STATE OF MINNESOTA
BEFORE THE PUBLIC UTILITIES COMMISSION

In the Matter of the Distribution System Planning
For Xcel Energy

PUC Docket No. E002/CI-18-251

**COMMENTS OF CLEAN GRID ALLIANCE, MINNESOTA CENTER FOR ENVIRONMENTAL
ADVOCACY, SIERRA CLUB AND THE UNION OF CONCERNED SCIENTISTS**

Figure 1. Xcel Distributed Solar Forecast for IRP²⁸

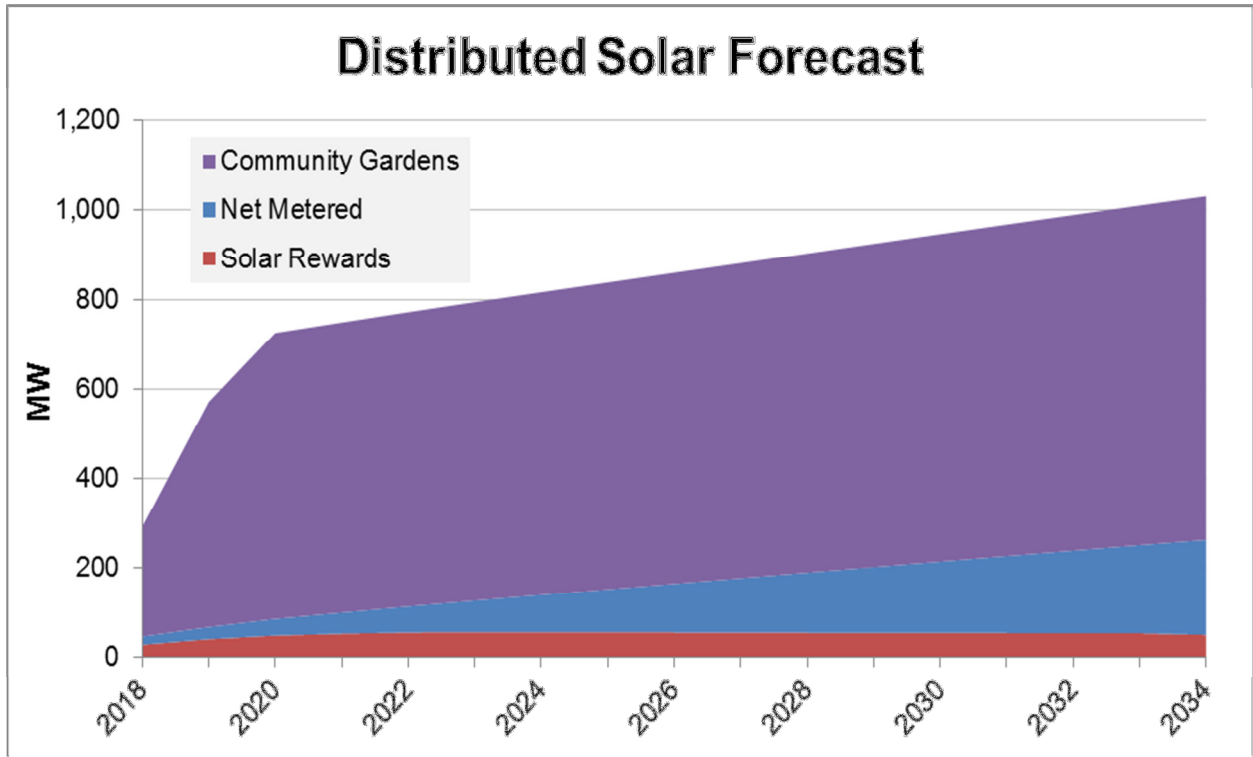
Xcel's Reference Case for per-year distributed solar additions (MW/AC) show a large drop-off in the solar forecast for the Solar*Rewards and S*R Community programs.²⁷ Its solar forecast is likely to understate solar adoption even in the "high" case since it assumes much less distributed solar uptake than what has been connected to the distribution system in recent years. Figure 1 shows the base case distributed solar forecast that Xcel plans to use for its upcoming IRP filing.

This forecast is similar to, though slightly different than the Base Distributed Solar PV forecast in the IDP. We understand that Xcel premised this forecast on distributed solar policy changes underway as well as working out the queue of distributed solar projects that has been built up. While policy is an important driver of solar adoption, there is always the possibility that continued reductions in solar (and battery) prices will push these adoption rates higher than forecasted. The Base and High levels of Distributed Solar adoption differ by only 292.6 MW in the final year of the forecast. In our view, a more meaningful High band forecast, and one that would be useful for Xcel’s IRP, would simulate rates of adoption significant enough to have a meaningful impact on Xcel’s remaining load obligation, i.e., it would change the seasonal magnitude of load as well as overall total load such that resource acquisition and retirement decisions are impacted.
